12/16/2016

## Safety Recall for the Enforcer

## **You can still use your Enforcer if:**

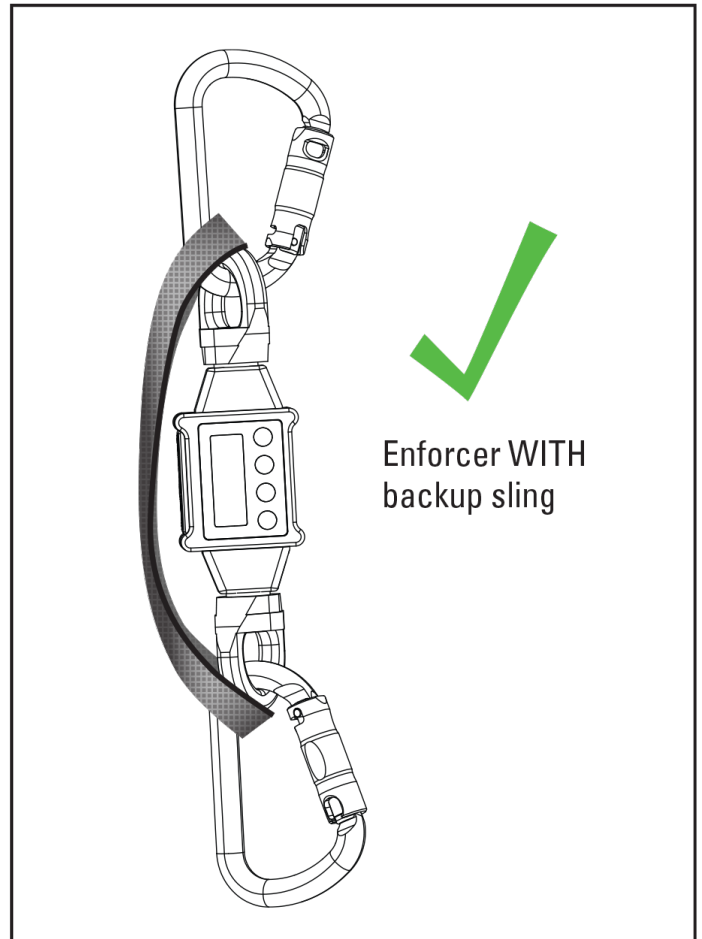
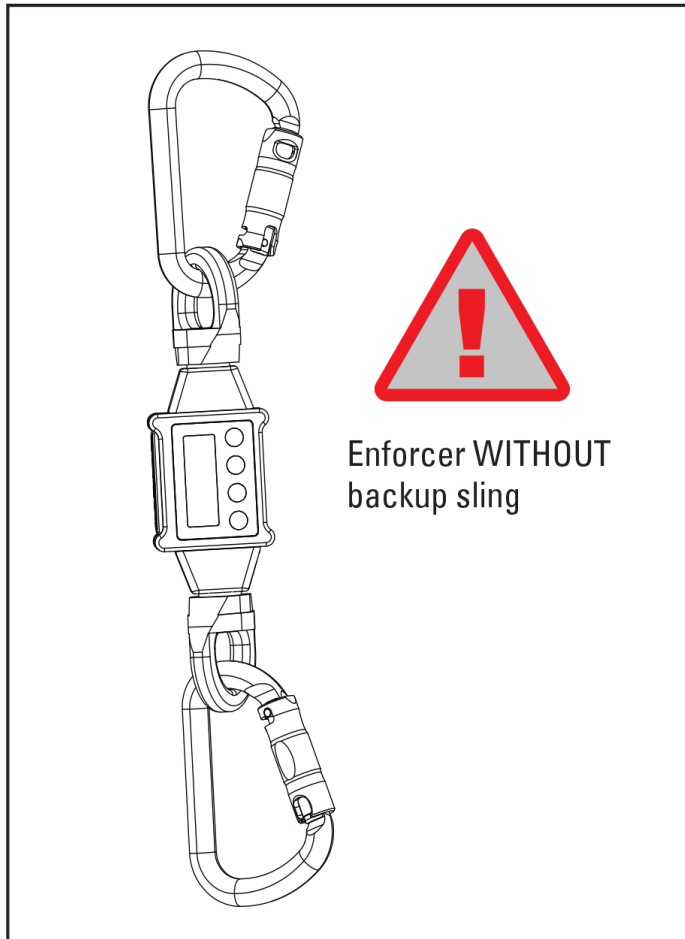
It is mandatory that you send your Enforcer in for the safety modifications as soon as possible. However, you can temporarily use it before sending it if you install a backup. Users are allowed to attach a PPE rated sling with MBS of 22 kN and a maximum of 25 cm (10 in) in length to the carabiners on either side of the Enforcer.

You must also: 1) inspect before and after each use, paying attention to making sure the swivel bolts are not loose, and 2) Do not use for high-speed or multiple rotations. Use for orientation only. 3) Do not use with steel cable. If you have any question of concerns, do not use it.
